Serial No.: 10/801,307

Amendments To Drawing Figures

REMARKS

**Fig. 5**

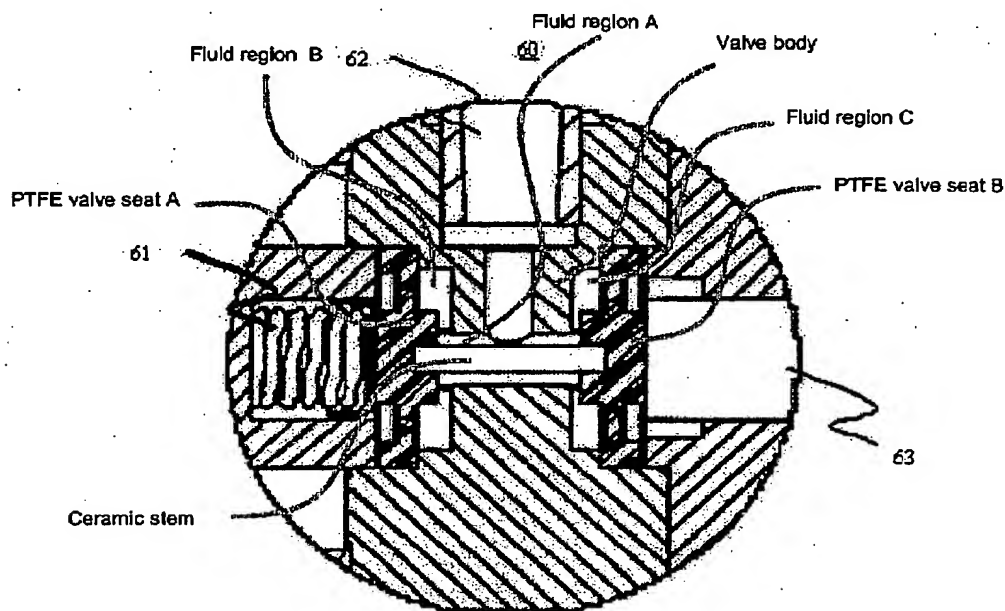
Claims 2, 4, 11 and 19 are rejected under 35 USC § 112, first paragraph as allegedly failing to comply with the enablement requirement. In particular, the Examiner is concerned that one of ordinary skill in the art would not understand how the valve returns to its neutral state. This rejection is respectfully traversed.

As noted in paragraph [0028], the exemplary embodiment 70 of the three-way valve illustrated in FIG 9 involves a modification of a known Takasago three-way valve, which is shown in varying views in FIGS 2-8. As described in paragraph [0002] of the Background, and as perhaps best seen in FIG 5 (presented below with annotations), the existing three-way valve is a pneumatically activated valve (via pneumatically activated plunger 63) with a spring return 61. The existing valve contains an assembly that includes two PTFE valve seats mechanically interlocked with a small ceramic stem ("the assembly"). As can be seen from FIG 5, the PTFE valve seats are fixed such that they can't move horizontally without deformation. Moreover, the PTFE valve seats are elastic and in the absence of any horizontal force (i.e., pneumatic force or spring force), would be centered with respect to the valve body (which is shown in right-hand downward cross-hatching) such that both valve seats are open. However, when the plunger 63 of FIG 5 is pneumatically activated, it drives the assembly to the left. This overcomes the force being exerted by the spring return 61 and allows the PTFE valve seat A to pull away from the valve body, resulting in fluid communication between fluid region A (which is connected to a first common port) and fluid region B (which is connected to a second port). This also pushes the PTFE valve seat B against the valve body, precluding fluid communication between fluid region A and fluid region C (which is connected to a third port). On the other hand, when the pneumatic pressure is removed, the assembly is driven to the right by the spring return 61, forcing the PTFE valve seat A against the valve body, and preventing fluid communication between fluid region A and fluid region B. The PTFE valve seat B, on the other

hand, is pulled way from the valve body, allowing fluid communication between fluid region A and fluid region C. Thus, due to the presence of the spring return in the valve of FIG 5, there is *always* an actuating force, even when the supply pressure operating the valve is removed (e.g., when the valve is not in use). Consequently, there is never a situation in which the assembly is not being urged to the left or right, and thus the assembly is never allowed to become centered with respect to the valve body (due to the elastic rebound of the PTFE material) such that both valve seats are open (i.e., at its "equilibrium" position). Moreover, when the supply pressure operating the valve is removed from the valve of FIG 5, the PTFE valve seat A is forced against the valve body by the spring return, allowing the valve to be glued shut.

In the present invention, on the other hand, both valve seats are pneumatically driven and there is no spring return. Thus, when the pneumatic force is removed from the valve (e.g., when the valve is not in use) the assembly is neither forced to the left nor to the right, allowing the assembly to return to its centered "equilibrium" position wherein both valve seats are open. This completely opens the valve (i.e., establishing fluid communication between fluid region A and fluid region B at
